Encana Oil & Gas (USA) Inc. is requesting authorization to install gas lift at the Lybrook E29-2306 03H well. Attached is a schematic of the pad with gas lift and the gas allocation procedure.

# Lybrook E29-2306 01H, 03H

## Gas Measurement Allocation Procedure for Lybrook E29-2306 Well Pad

### **CONDITIONS OF APPROVAL FOR GAS LIFT, BUY BACK METER AND CDP INSTALLATION:**

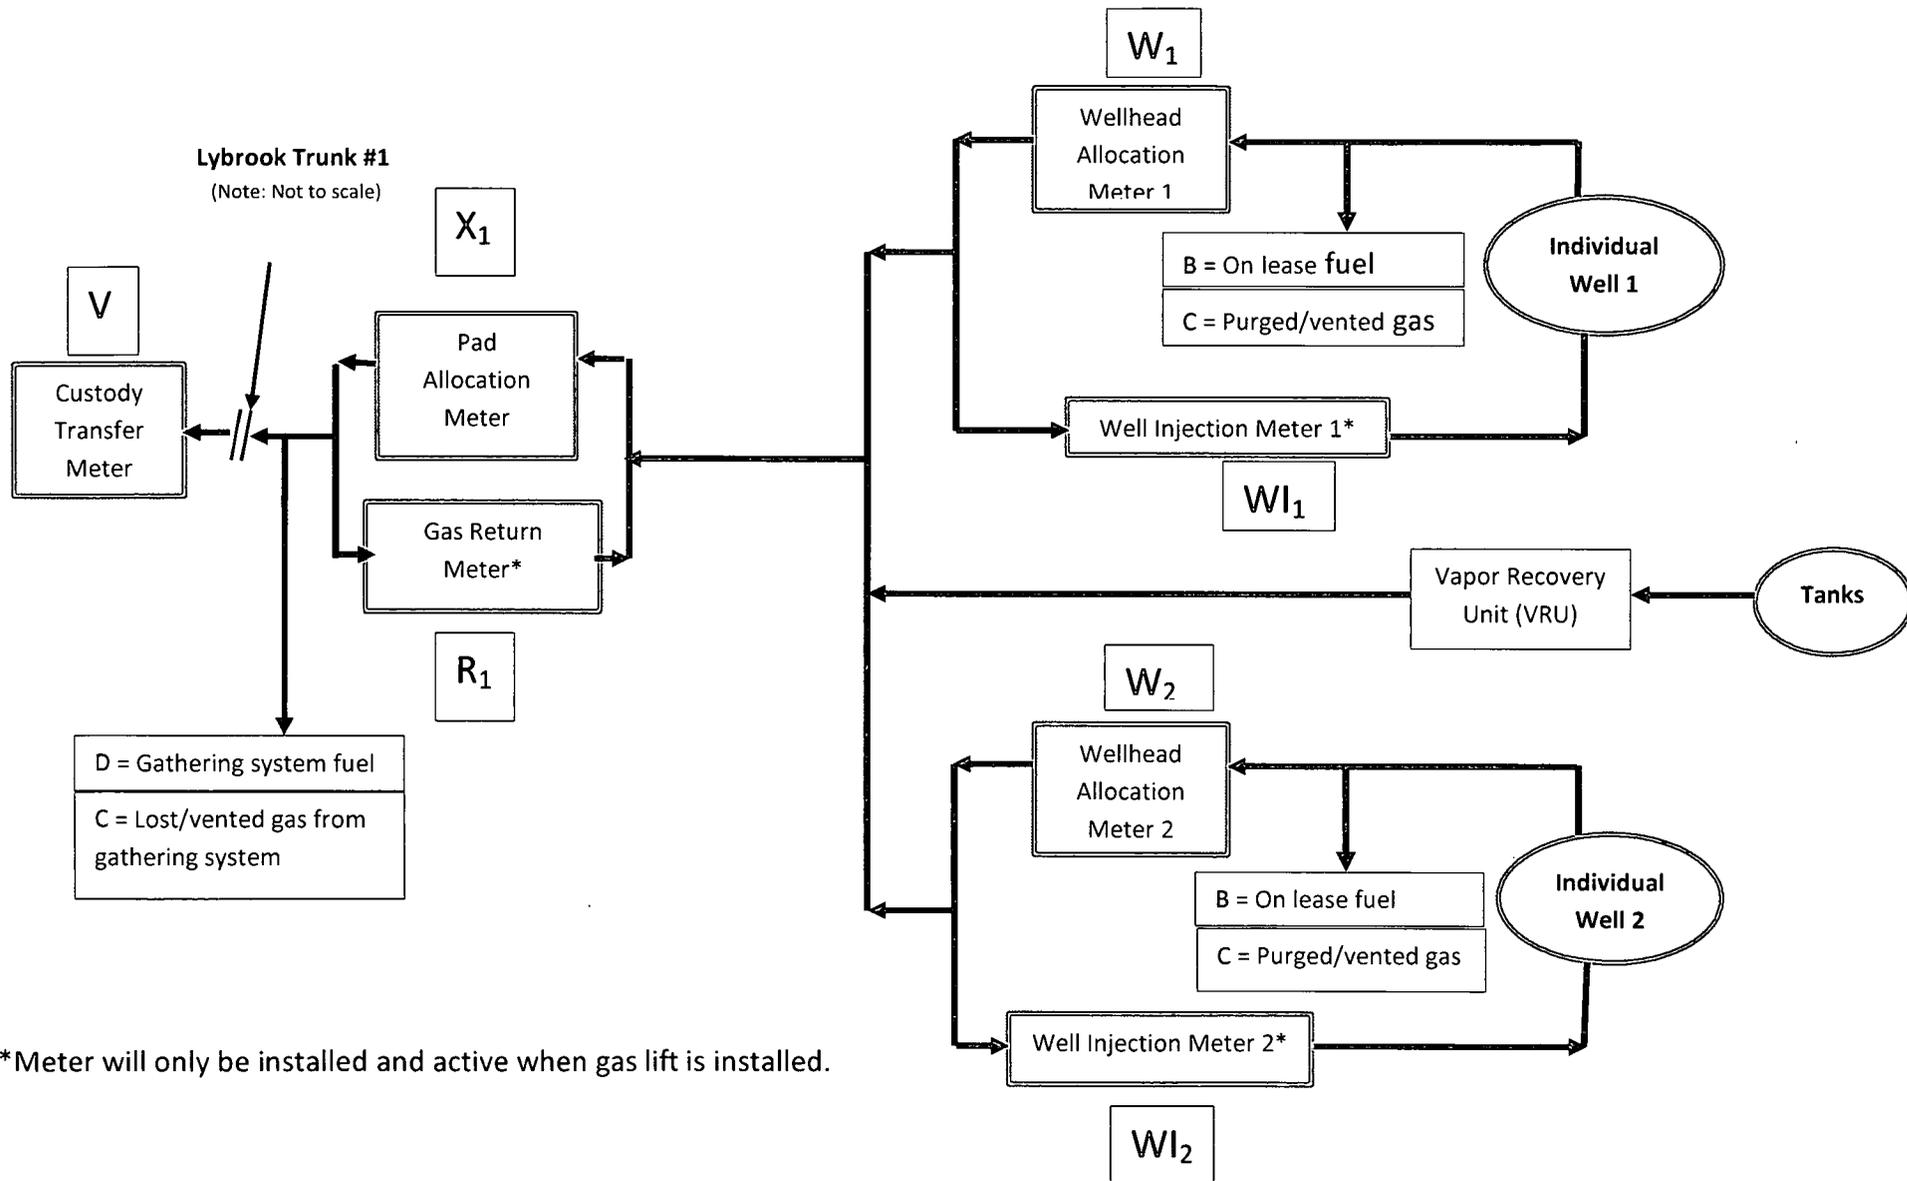
- The buy-back meter isolation valve, either up or down stream of the buy-back meter must be effectively sealed in the closed position to prevent produced gas from potentially by-passing the measurement and sales meter. In lieu of the seal requirement at least two check valves can be installed immediately upstream and downstream of the buy-back meter to prevent produced gas from potentially by-passing the measurement and sales meter.

Contact this office so a BLM witness may verify installation of either the seal or check valves.

- If seals are installed, seal records must be maintained and made available upon request.
- Post a Facility sign at the CDP listing the following information:
  - Operator Name
  - Facility Name (i.e. Lybrook E29-2306 03H CDP)
  - UL, S-T-R, County and State

**Clearly identify both the sales and by-back meters.**
